# AGENDA

**The Columbia Architectural Design Review Team will meet on Tuesday, June 7th, 2022 at 8:00 a.m. in Conference Room A on the basement level of City Hall, 700 N. Garden Street to consider the following:**

8:10 AM 22-0119 - 2008 Main Street - Modify Façade Of Existing Building  
Request from Richard Thompson on behalf of Ritco Group, Inc for façade modifications at 2008 S. MAIN STREET.

**PLANNING STAFF EVALUATION:**

SHEET #:  
DA-2

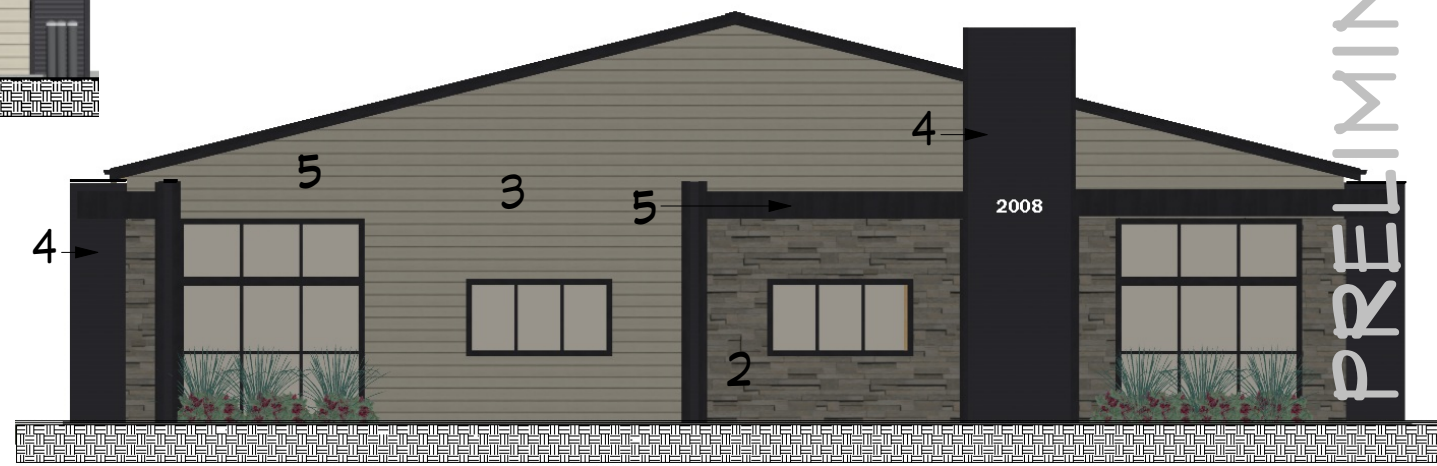
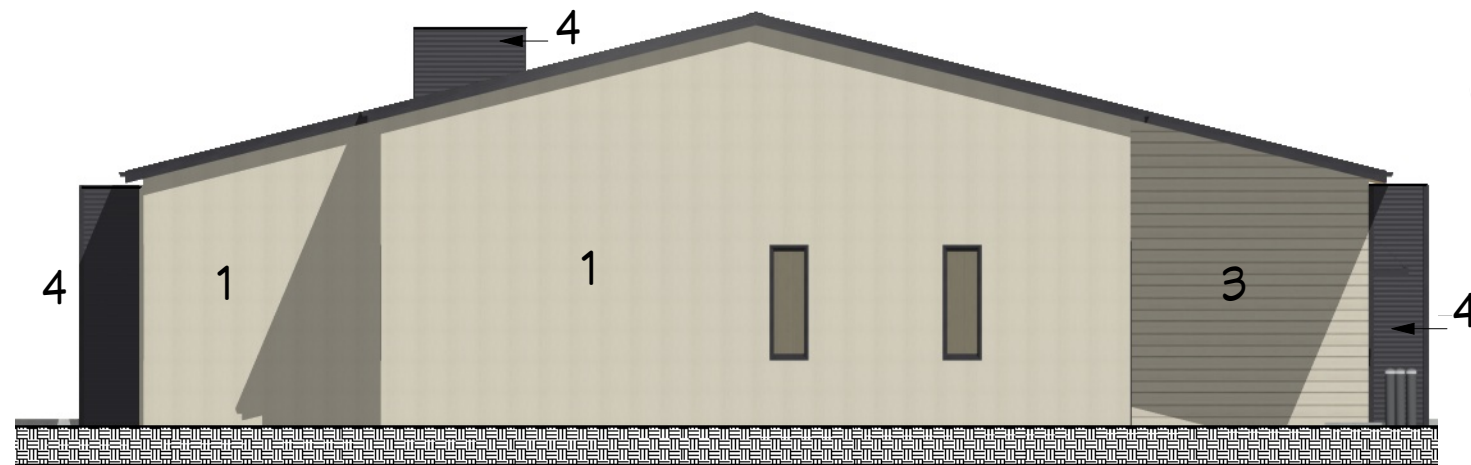
This request is for the façade modification of an existing pre-fabricated metal building. The modification consists of recladding of a corrugated metal façade with fiber cement board and additional window openings including a front tower addition.

- The front facade consists of the recladding of metal with fiber cement board and the material change from brick to a ledge stone. Alternative compliance has been requested to allow for corrugated metal accents to the front façade. These materials meet the design standards as referenced with the exception of corrugated metal.

- A left and right elevation indicate the primary facade materials of a fiber cement board and batten including fiber cement board lap siding. In addition, a metal clad awning has been added over door openings. These materials meet the design standards as referenced.

- The rear elevation consists of the primary façade materials of board and batten lap siding including horizontal siding material consisting of fiber cement board. These materials meet the design standards as referenced.

- Alternative compliance has been requested to allow for minor sections of corrugated metal to be integrated in the faced change located at a proposed tower and end cap of the elevations.

Sheet Number  
**A 3.1**

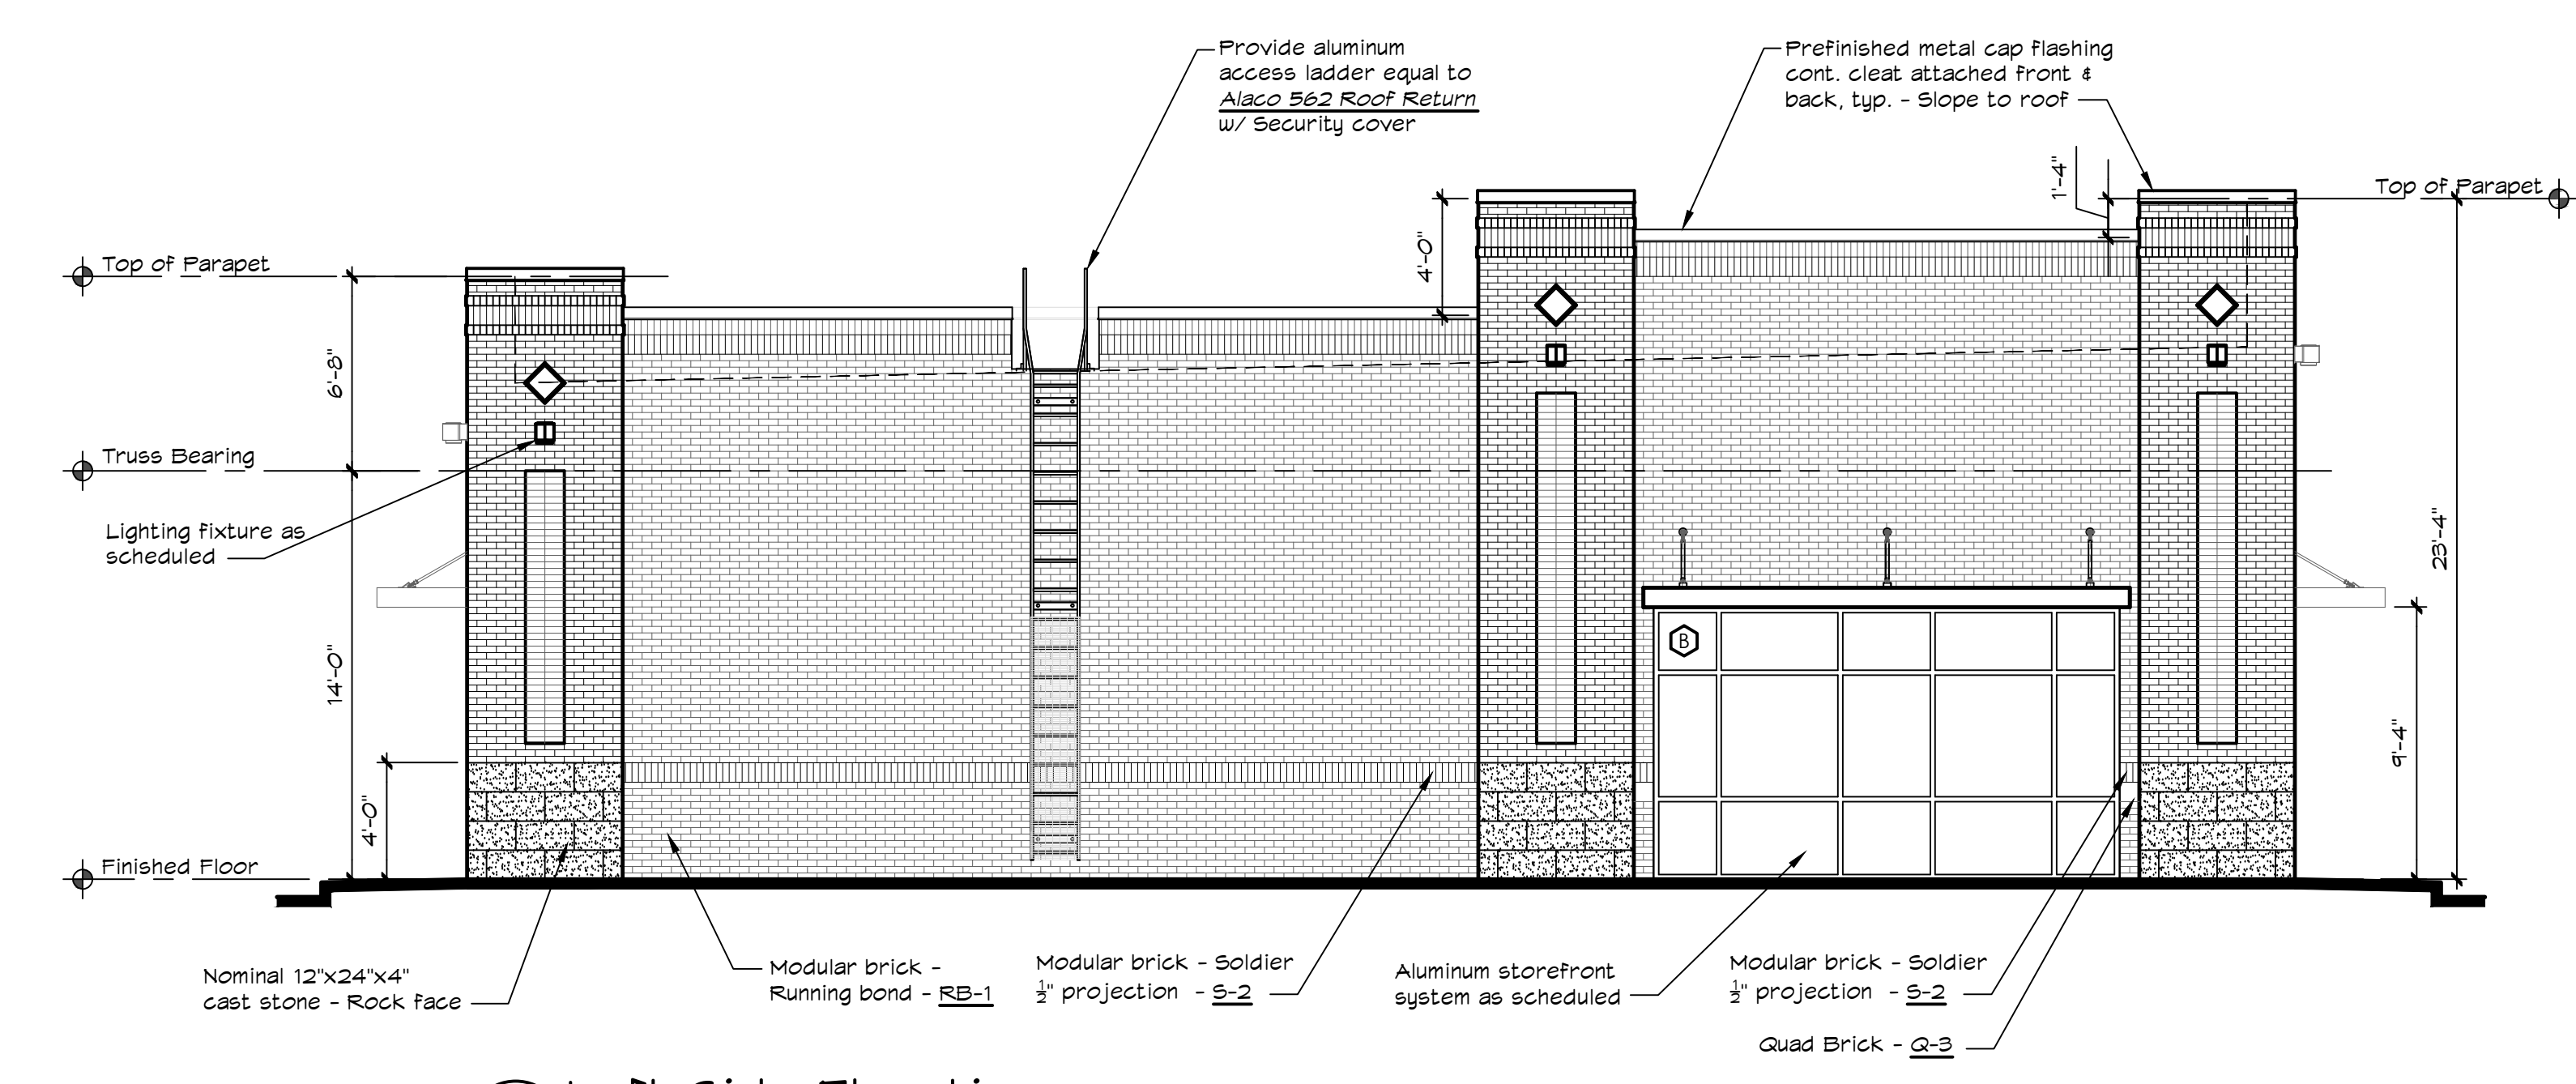
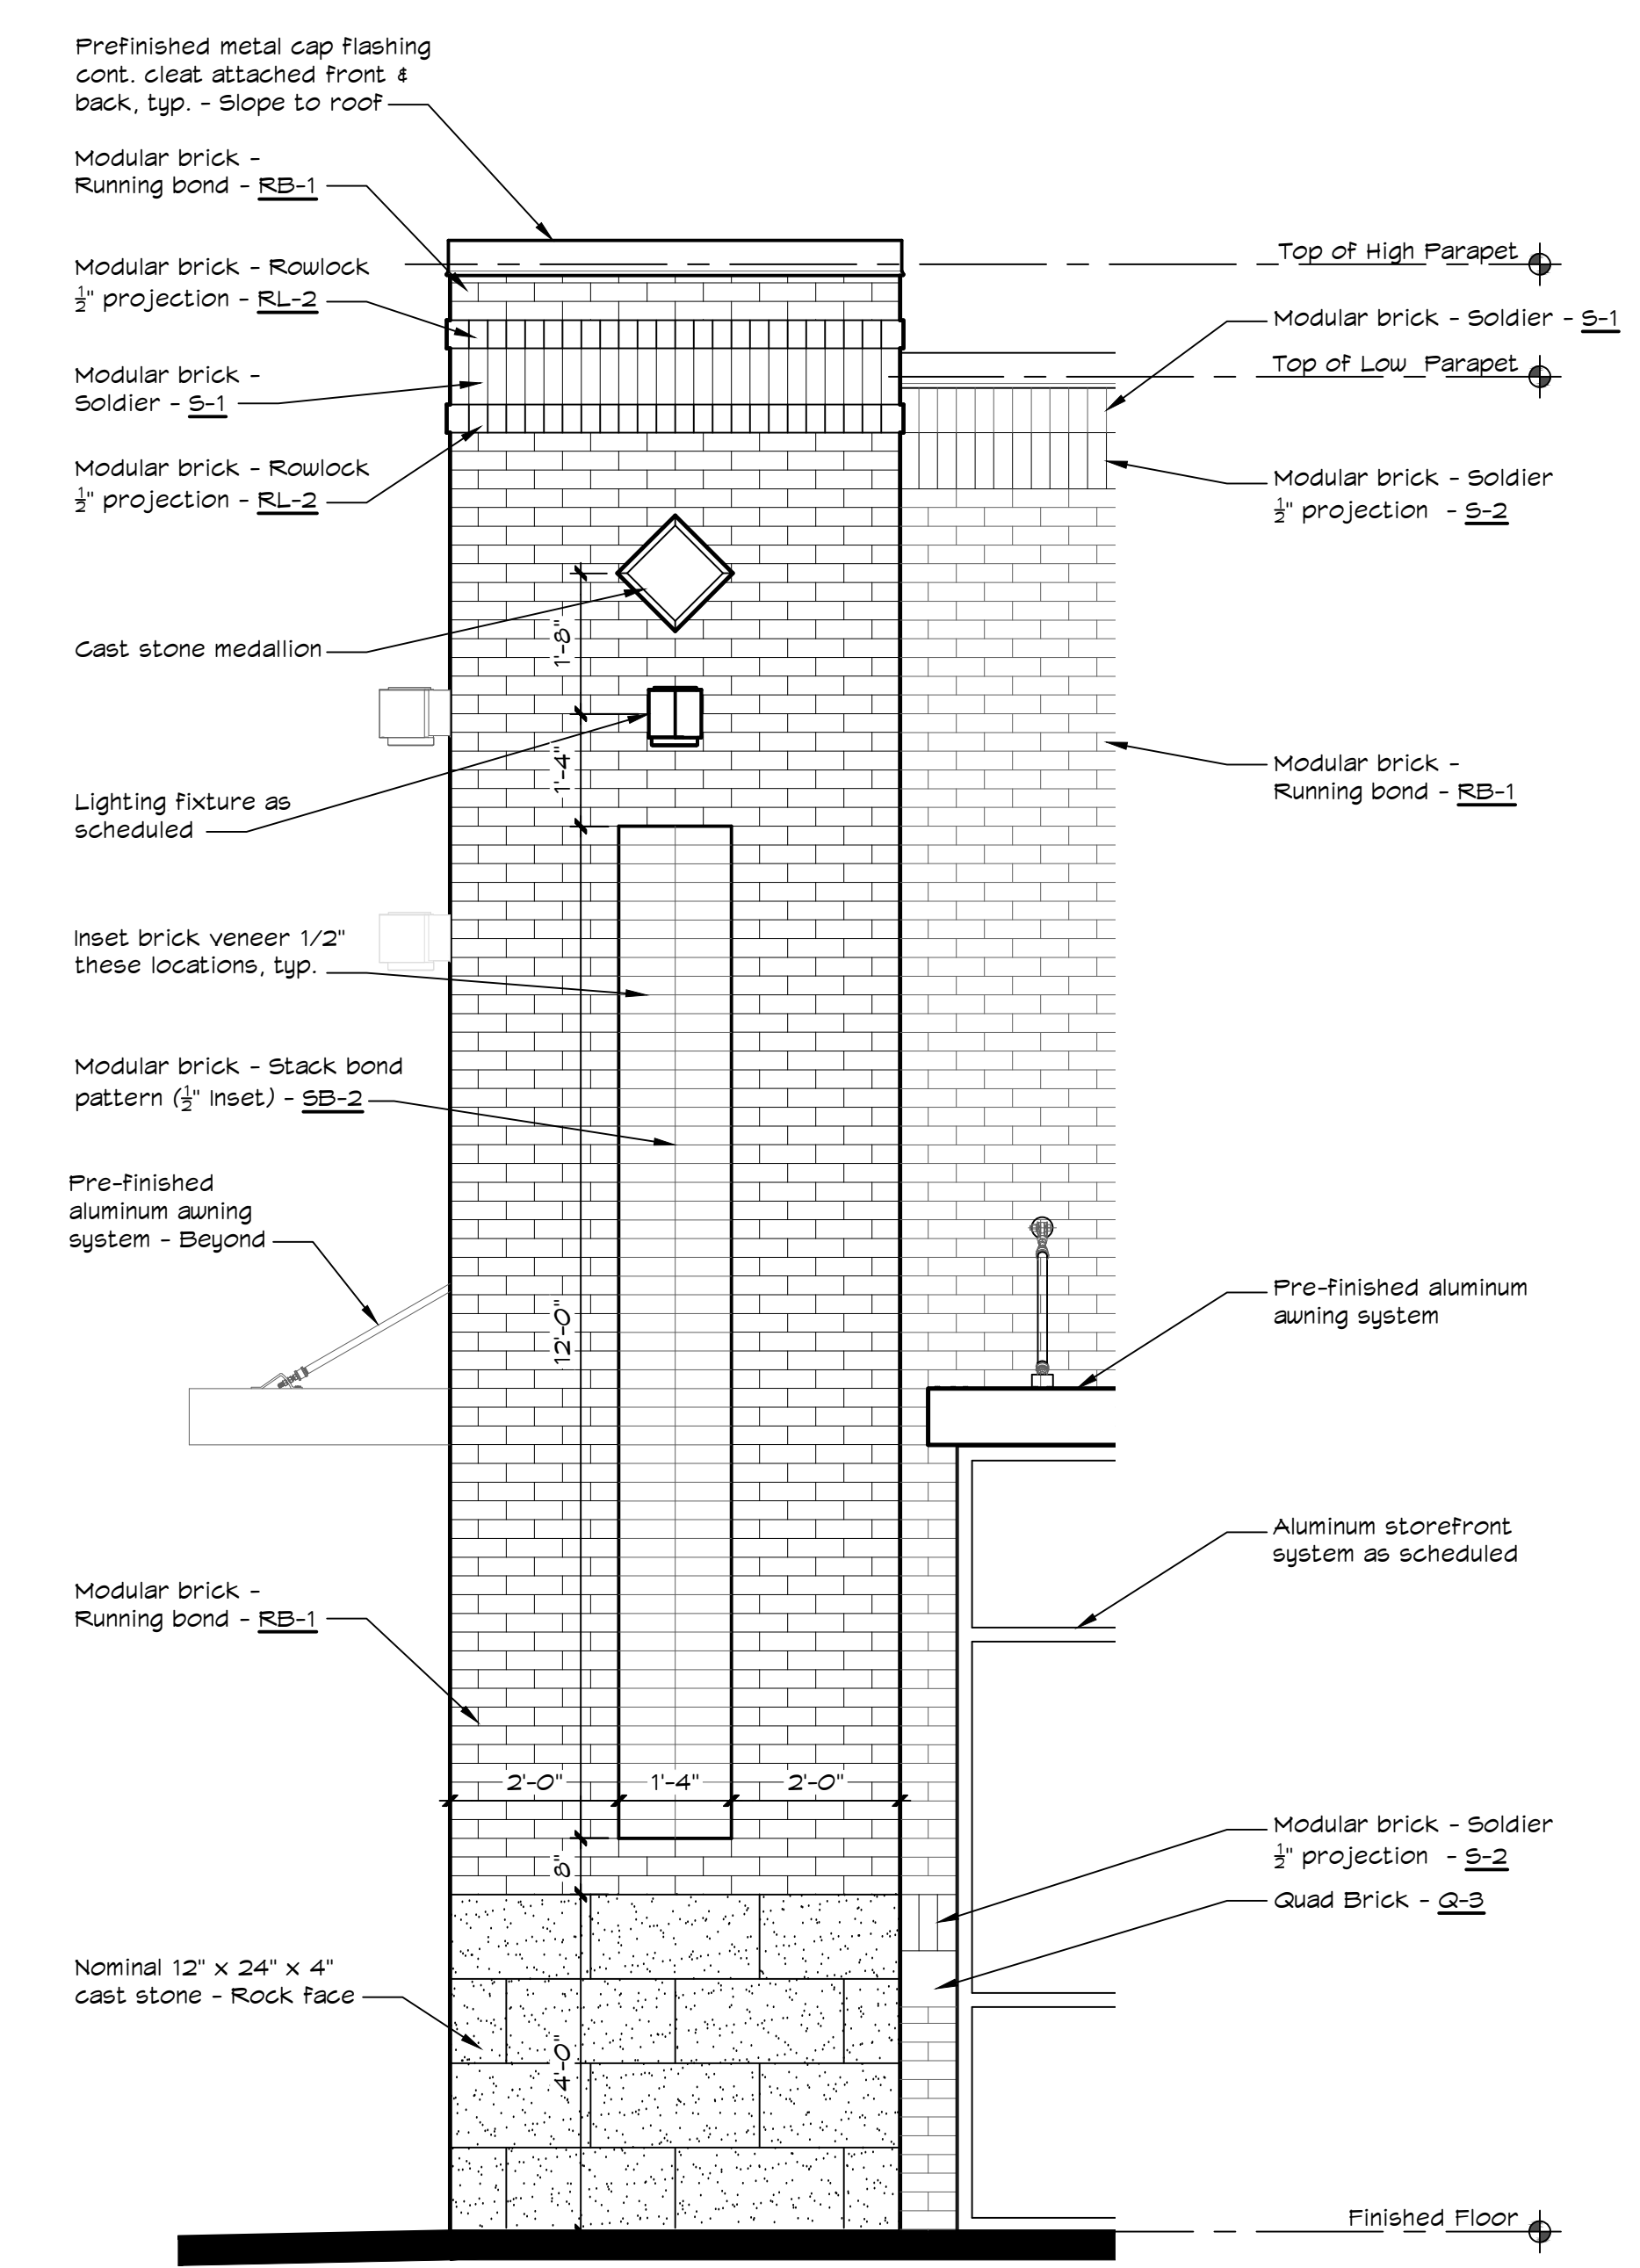
- The proposed west (rear) building elevation will consist of a primary façade material of brick accented by brick soldiering within the base and the columns. Each individual pilaster will be accented by a stone medallion detail. Aluminum storefront windows will be facing the Cayce Lane elevations. The front elevation will consist of the same primary façade materials as the rear elevation with a combination of brick details separated by brick pilasters.
- The right and left (side) elevations will consist of a primary brick material as all other elevations with a 4' recessed parapet.
- It shall be recommended that as a condition of approval that all rooftop HVAC equipment be screened by the raised parapet with no exterior visibility.
